Wisconsin Department of Transportation

Proposal #10: 1060-34-84
Zoo IC, Center Street Bridge
Over USH 45
USH 45
Milwaukee County

1060-35-85
Zoo IC, Center Street Sidewalk
114th Street to 117th Street
Off System
Milwaukee County

This is Addendum No. 01, which provides for the following:

Addendum No. 01
ID 1060-34-84 &
ID 1060-35-85
Revised Sheet 59
November 30, 2015

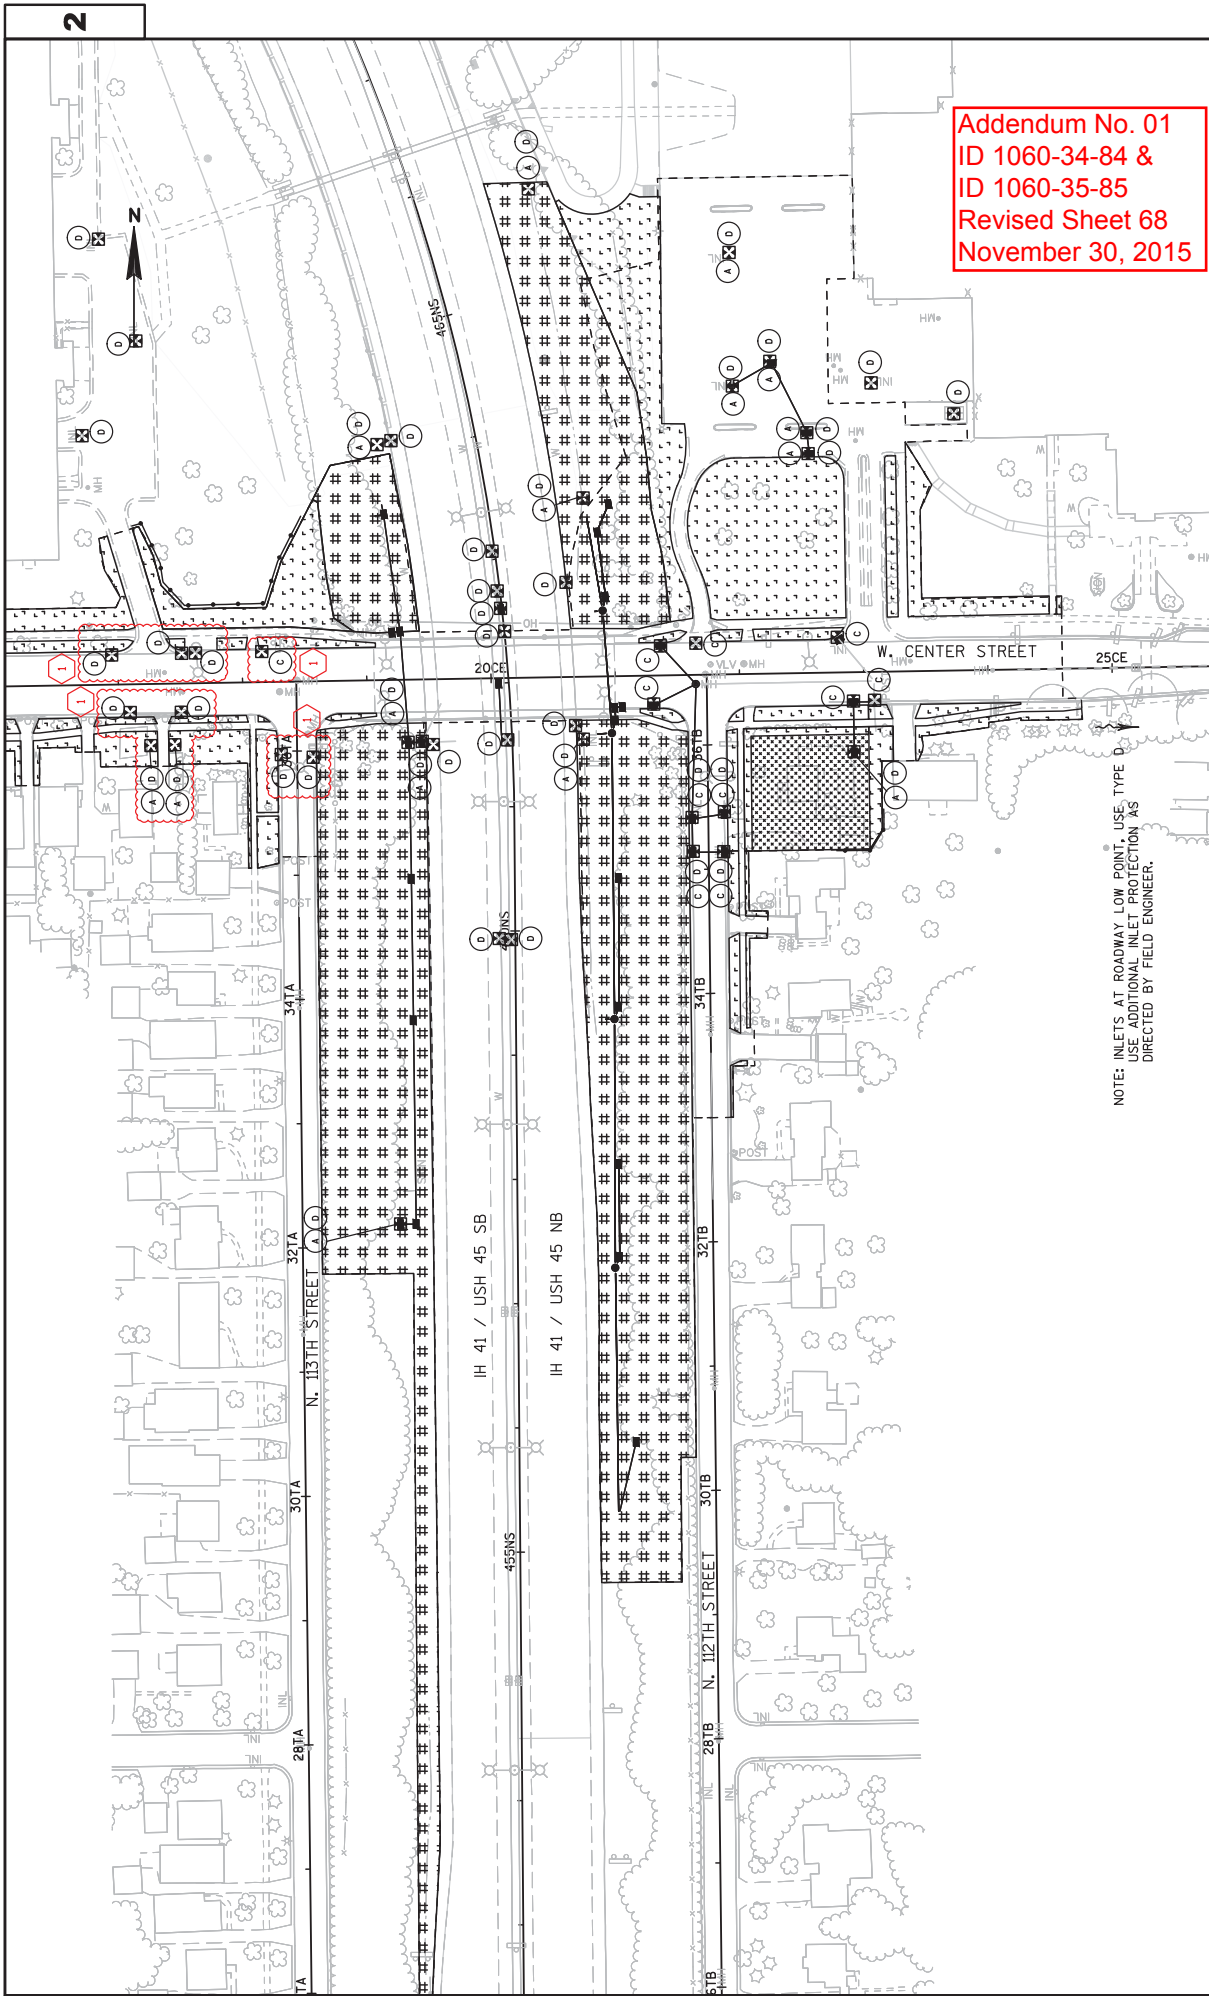
| Revised Plan Sheets | |
|---------------------|---|
| 59 | Contour Map – Removed sections of proposed storm sewer due to Wauwatosa storm sewer project |

Addendum No. 01
 ID 1060-34-84 &
 ID 1060-35-85
 Revised Sheet 68
 November 30, 2015

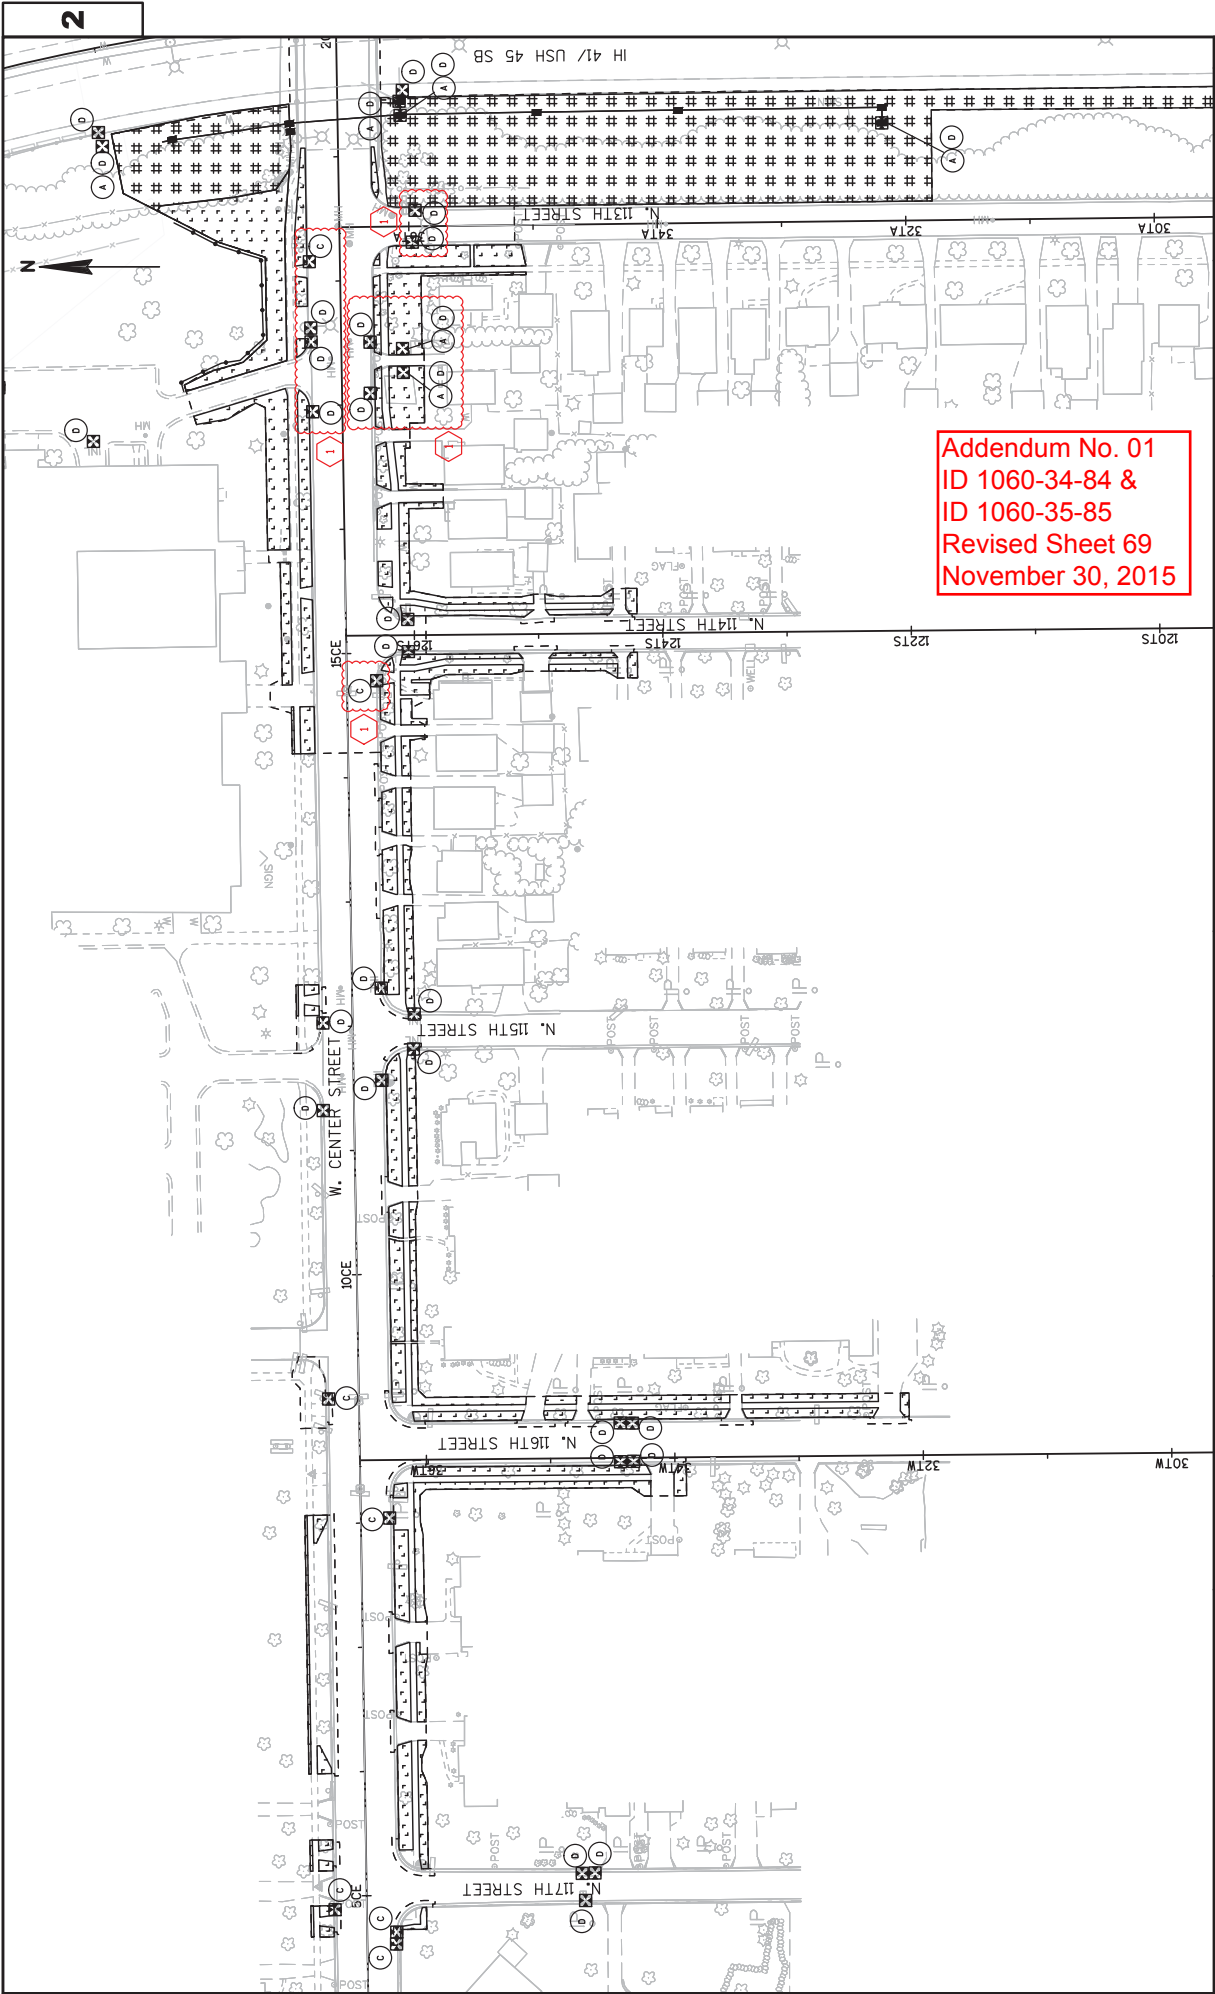
| Revised Plan Sheets | |
|---------------------|---|
| 68 | Erosion Control – Removed sections of proposed storm sewer due to Wauwatosa storm sewer project |

BACKFILL SLURRY DETAIL - STORM SEWER STRUCTURES

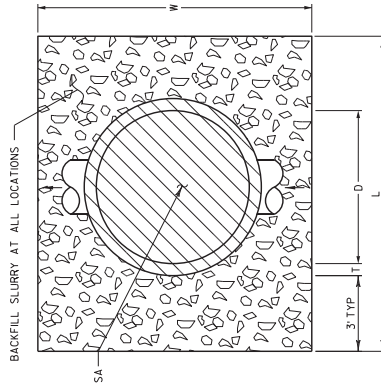
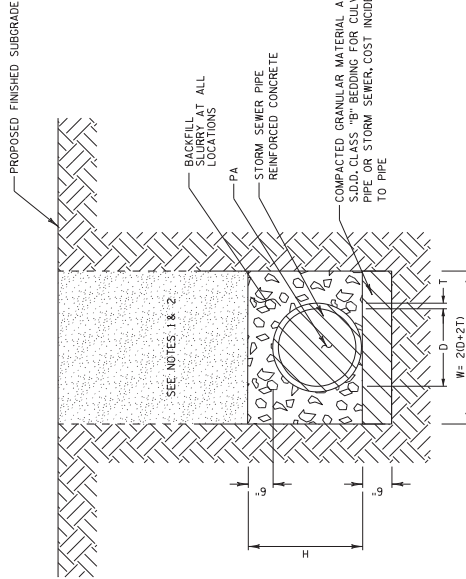
| Revised Plan Sheets | |
|---------------------|---|
| 75 | Storm Sewer - Construction Details – Added applicable station ranges for backfill slurry |

APPLICABLE STATION RANGES:
 455NS+0.0 TO 464NS+0.0

Addendum No. 01
ID 1060-34-84 &
ID 1060-35-85
Revised Sheet 79
November 30, 2015

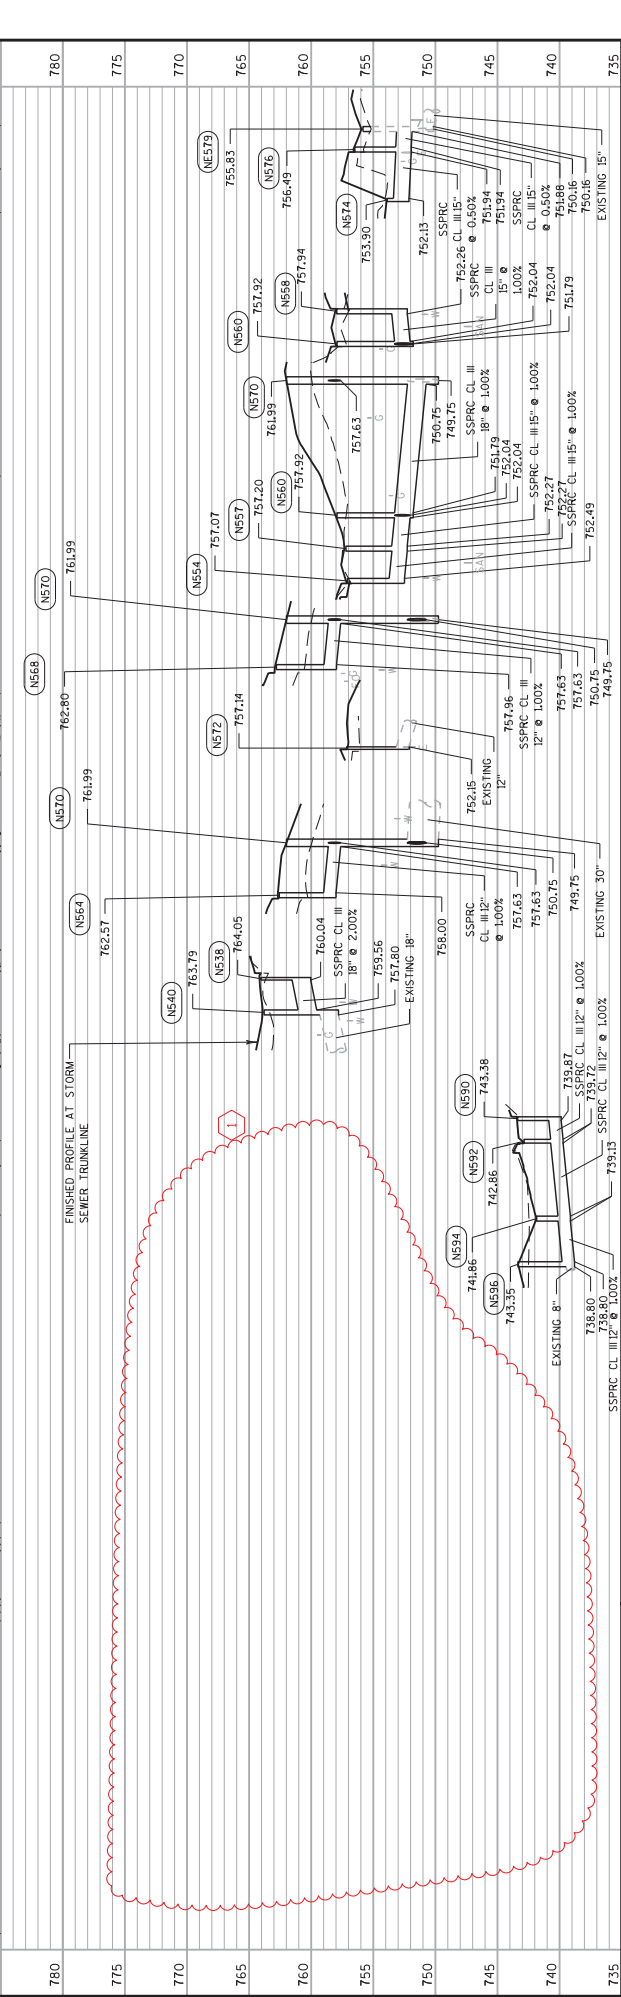
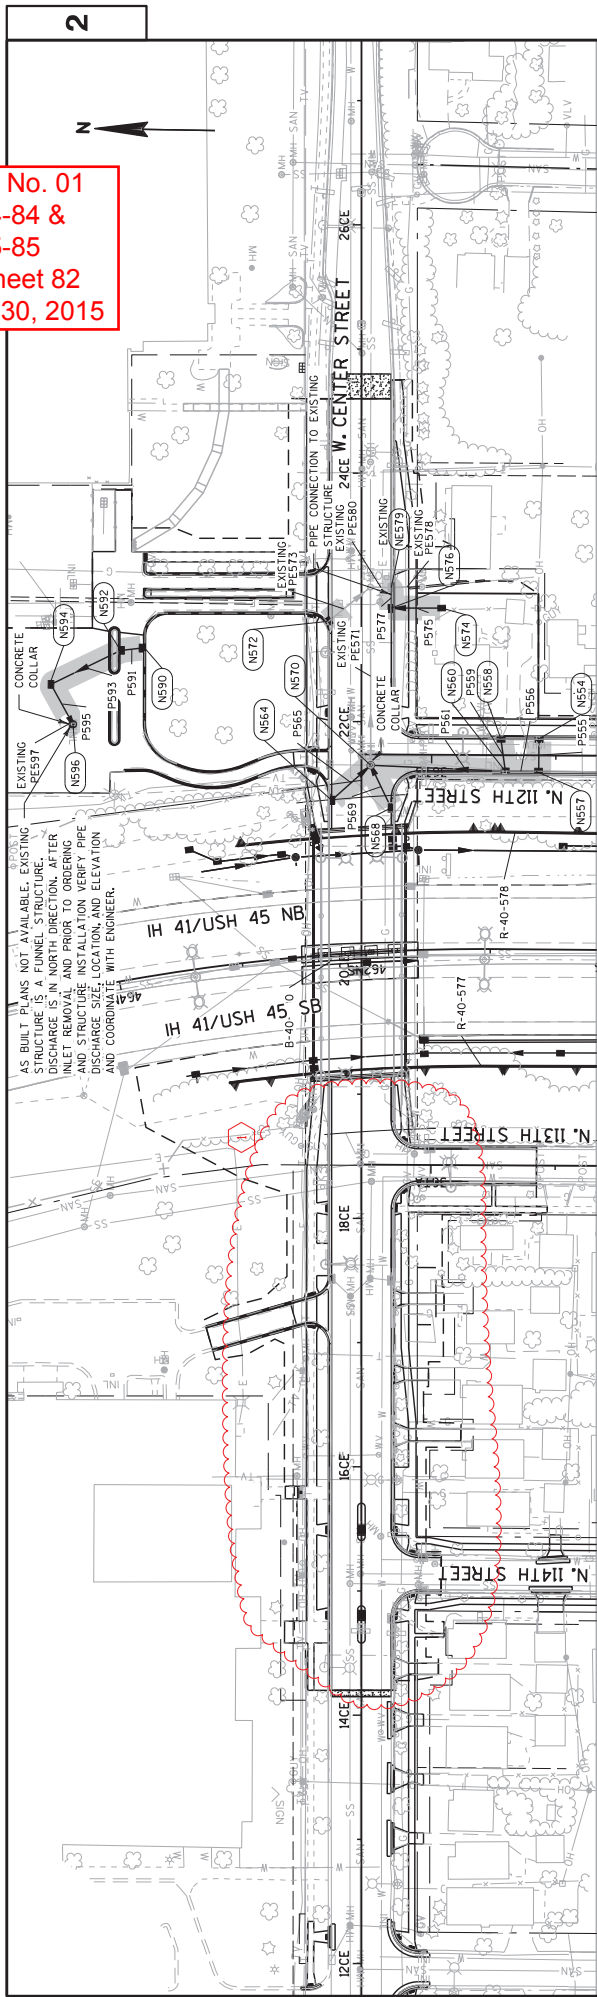
| Revised Plan Sheets | |
|---------------------|---|
| 79 | Storm Sewer - Removals – Removed activities due to Wauwatosa Storm Sewer project |

Addendum No. 01
ID 1060-34-84 &
ID 1060-35-85
Revised Sheet 82
November 30, 2015

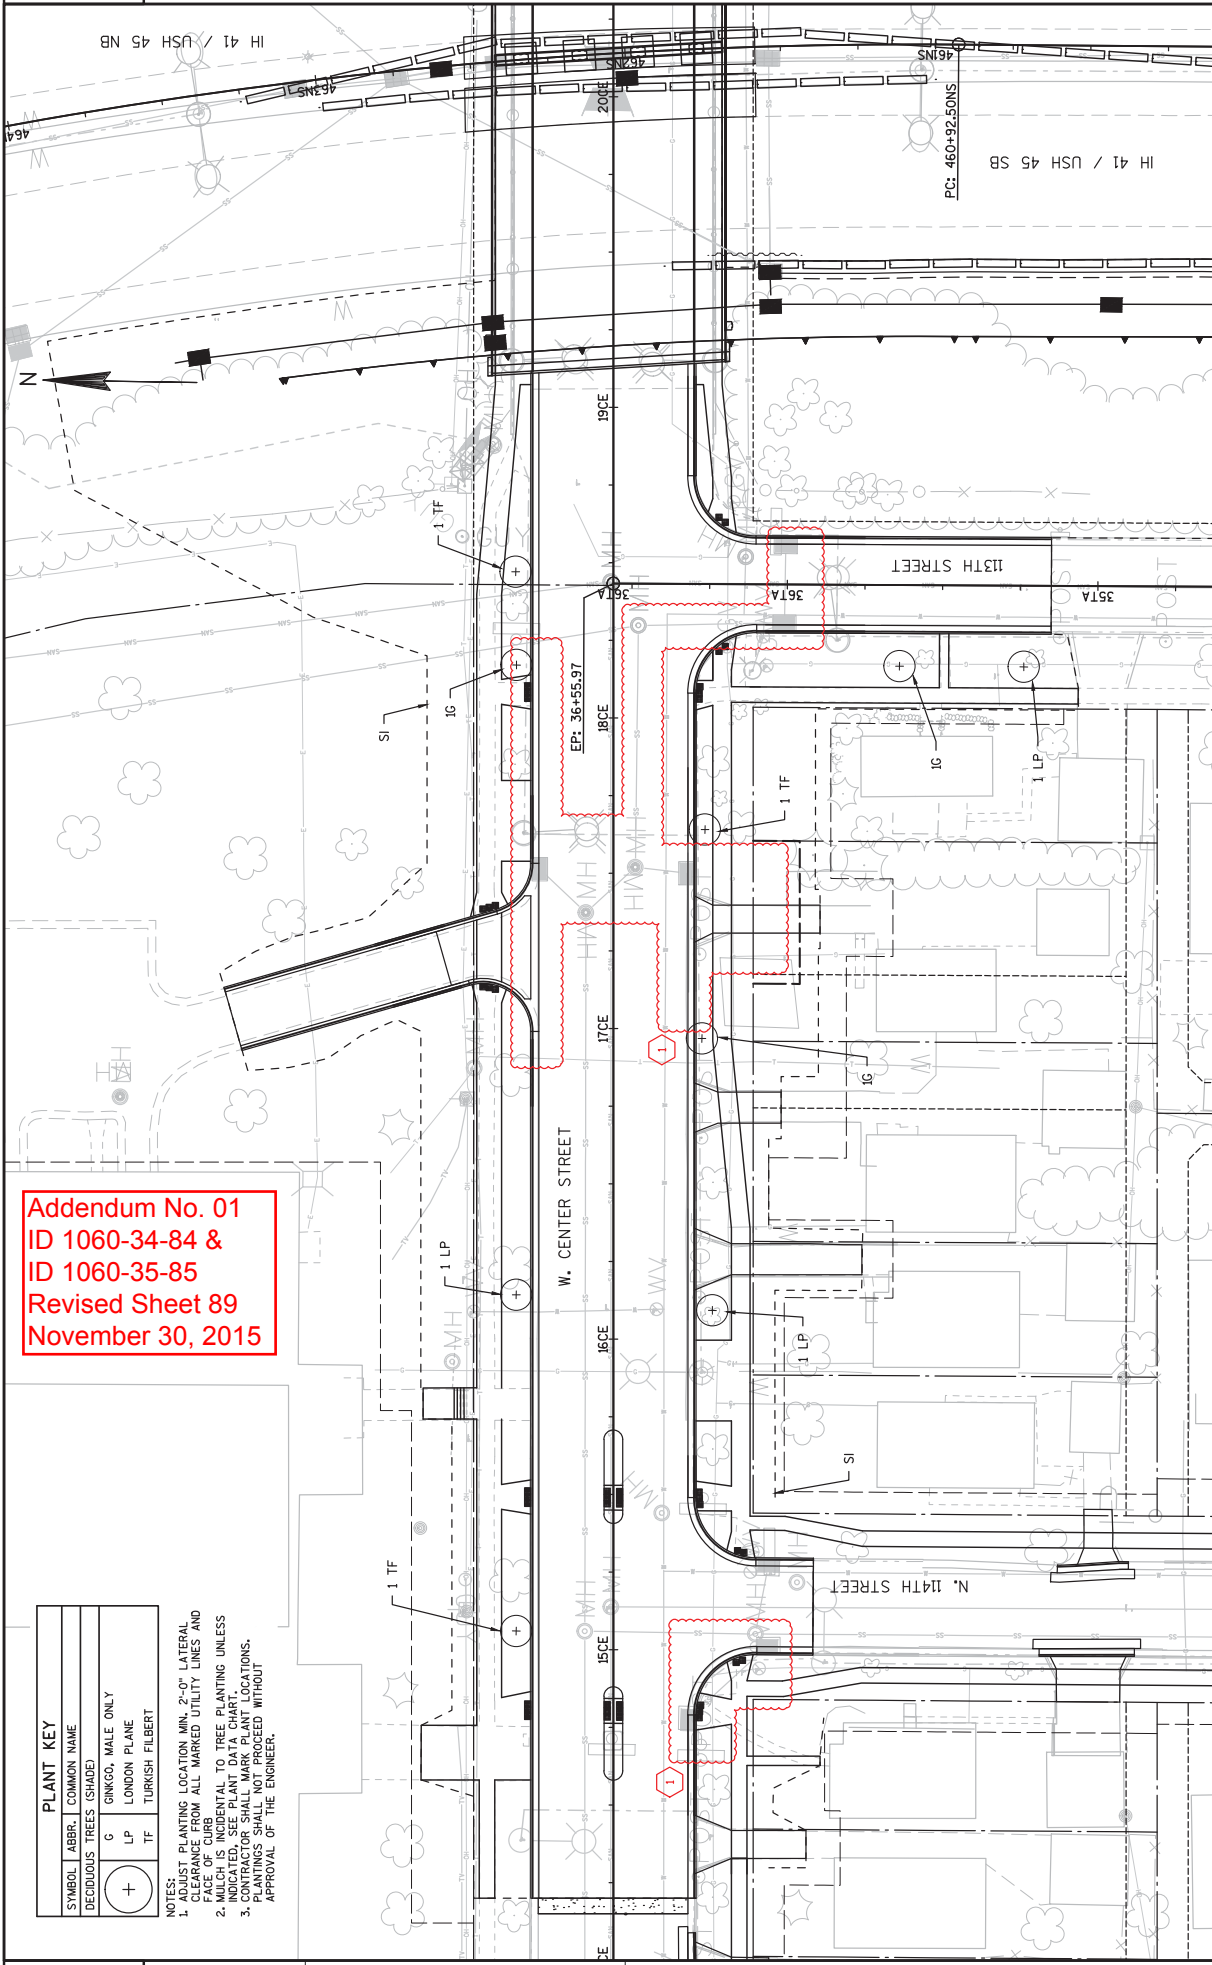
| Revised Plan Sheets | |
|---------------------|---|
| 82 | Storm Sewer - Removals – Removed activities due to Wauwatosa Storm Sewer project |
